AGENDA ITEM SUMMARY

September 1, 2015

Resolution 2015-082 Directing the City Manager to Submit to the U.S. Army Corps of Engineers the City's Comments on the Supplemental Draft Environmental Impact Statement for the Northern Integrated Supply Project

Figure 3-101. Percent change in adult brown trout habitat from existing conditions on the Colorado River below Windy Gap for an average water year.

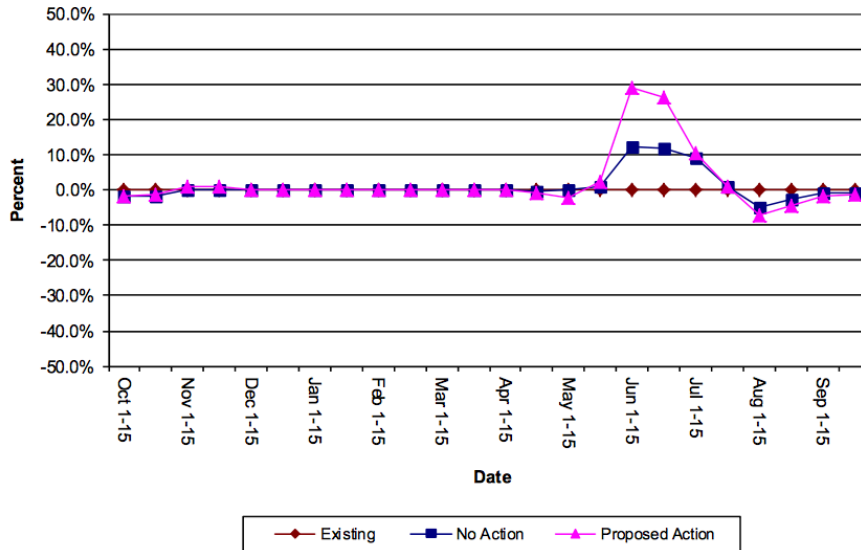
The discussion on page 4-314 of the SDEIS discusses changes in habitat with changes in flow. However, there is no means to verify any of the statements since computational data for habitat-flow time series is not presented in the supporting aquatic resource technical documents. For example, the recent EIS for the Windy Gap firming project included the basic habitat time series data by water year type as part of the technical supporting documentation (see following example figure, Windy Gap Firming Project FEIS). The display of habitat by water year type or actual year allow the reader to make a direct comparison of habitat change between alternatives.

The aquatic habitat analysis up through the development of habitat versus flow determinations follows the standard approach used in instream flow studies. (Bovee et al. 1998, USGS 2001). The divergence from the standard approach is in the calculation of habitat over time. The use of a synthesized habitat values based on recurrence and then a single average value derived from the synthesized data masks the relationship of habitat over time. This approach does not allow a full analysis of impacts to the aquatic resources within Fort Collins, especially in the downtown corridor, which is highly valued

Proposal/Recommendation: The analyses and conclusions should be revised in these proceedings to address the deficiencies described above.

SDEIS Section 4.5.1 Methods, Pages 4-176 to 4-177

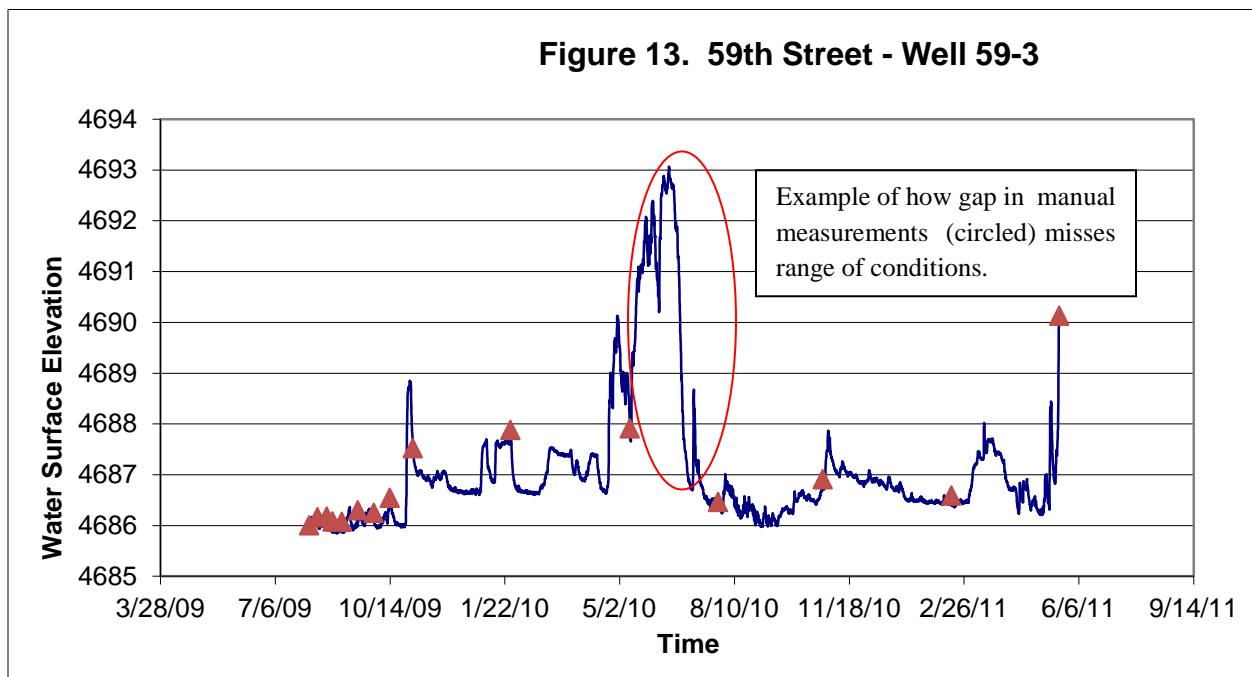
Comment: Data used to establish the river stage-ground water relationships appear not to be representative, complete, or consistently interpreted as described below.

As identified in Fort Collins' comments to the Draft Baseline Ground Water Technical Report in August 24, 2011, which are part of the administrative record in these proceedings, ground water wells at Lee Martinez Park may not be representative of the segment because they are located in areas that are supported by supplemental ground water recharge due to their proximity to a flooded gravel pit having a water surface that is maintained at an elevation about 10 feet higher than the river due to the inflow of "salvaged water." The SDEIS and the 2013 Ground Water Effects Analysis support the City's concerns from 2011. While it is true that upgradient groundwater recharge may occur in numerous other places along the river, the magnitude of these influences on the water table varies. For example, variation in groundwater levels is evident within the Martinez transect itself, where piezometers located at similar distances from the river but on opposite sides respond quite differently. During the EIS study, for example, the differences in reported ground water elevations for L3 and L4 – which are relatively equidistant and across the river from each other – was an average of 0.87 foot and ranged from 0.27 foot (9/16/09) up to 6.21 foot (5/11/09). These local variations in the aquifer make it questionable to apply relationships established based on distance from the river in one location to another location, even in the same segment.

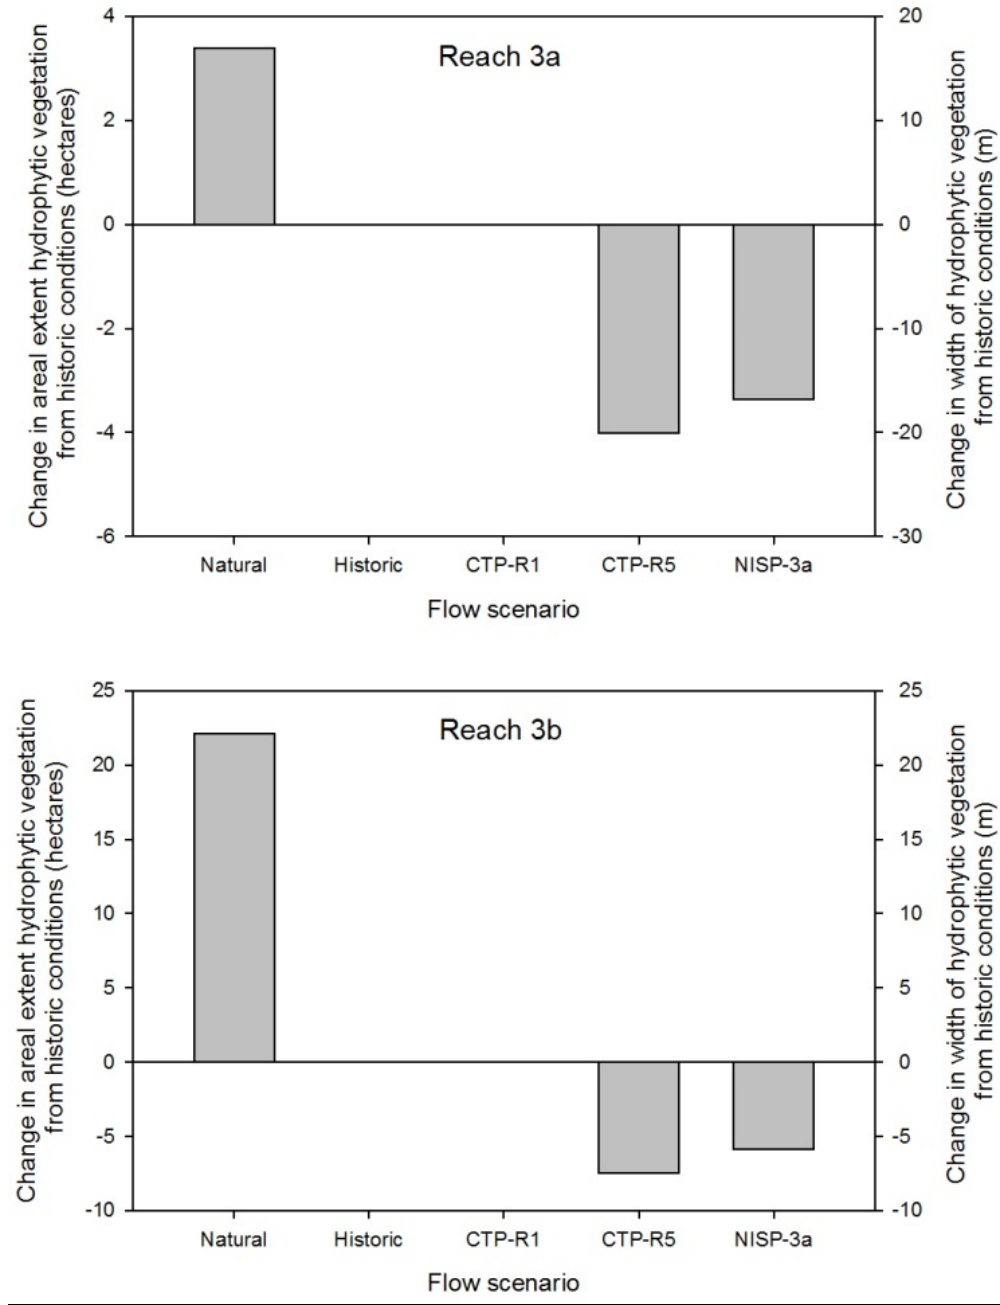
Any wetland community with the average groundwater table deeper than six inches may no longer be able to support wetland plant communities and wetland functions with a reduction in groundwater less than 0.5 foot. For example, cattail marshes would likely see a shift in species composition whereas drier wetlands like those dominated by *Carex nebrascensis* may be completely lost (Henszey et. al., 2004).

Proposal/Recommendation: The analysis should be revised to not include the assumption of uniform response to altered wetland hydrology as discussed above. If no alternate approach is applied, please provide examples of other federal permits or peer reviewed research that has used this approach to help the reader understand the basis for the conclusions reached.

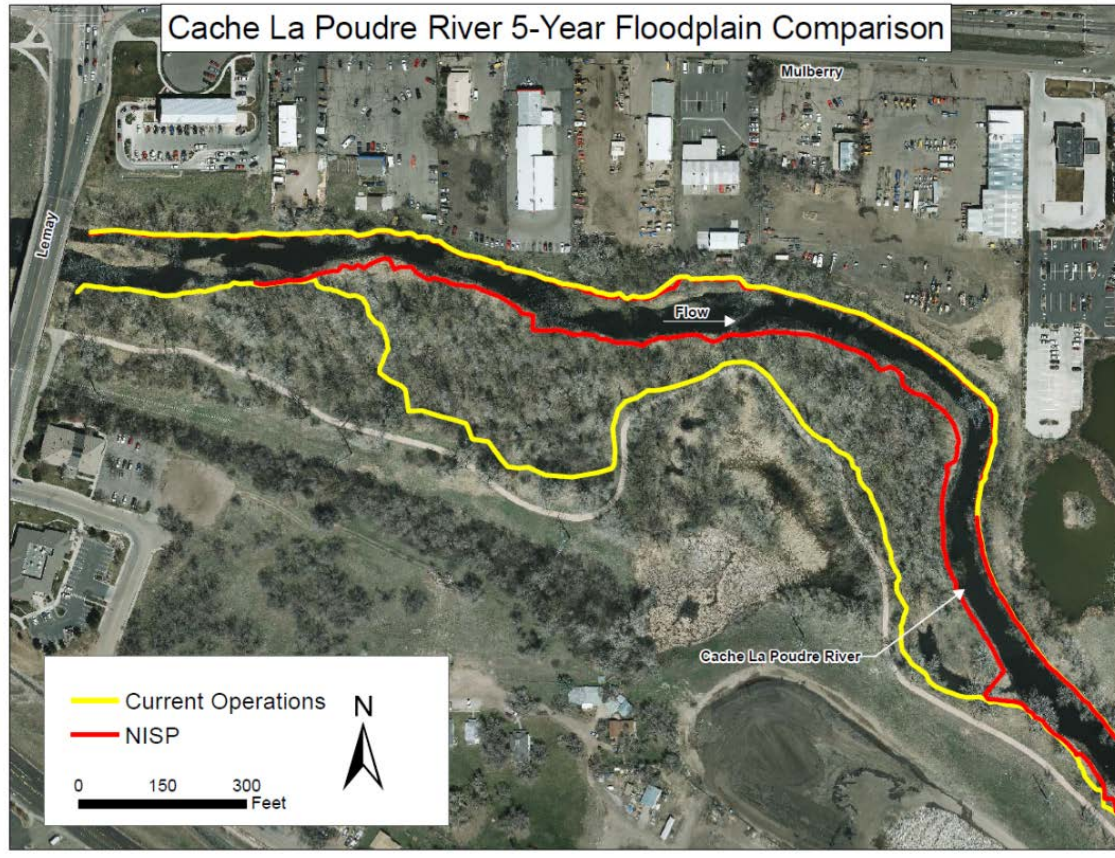
Fort Collins and its consultants calculated the 5 year flow at the USGS gage at the Lincoln St. gage using methods described in USGS bulletin 17b for historic, current conditions and Alternative 2 flow scenarios (see ERM Supplemental Report, Current Conditions and Alternative 2 and USGS, 1982). Respectively this flow is 3,486, 3,018, and 2,366 cfs. According to these flow values, this “moderate flow” appears within range of flows most affected by the preferred alternative.

The first three columns in this table present the average width (in meters including both sides of the river) of the 5-year floodplain for three RHAF river segments under various 5 year flow scenarios. The percent change from Current Conditions to the Preferred Alternative can be calculated as a way to present the expected change in ecologic services. This methodology and these river segments, are explained the RHAF (City of Fort Collins, 2015a). Due to bank armoring and channel constrictions the riparian forest is narrow for significant lengths in each of these river segments. In contrast, the sections with more natural low-lying floodplain topography are more likely to receive the benefits of inundation. For example, as portrayed in the photo below, the river section downstream of Lemay Ave. currently inundates the forest under the 5 year flow. With NISP the 5 year flow will not extend into the forest at all.

Proposal/Recommendation: The analysis should be revised to provide a spatial assessment of inundation alterations and the effects to the riparian environment, as described above.
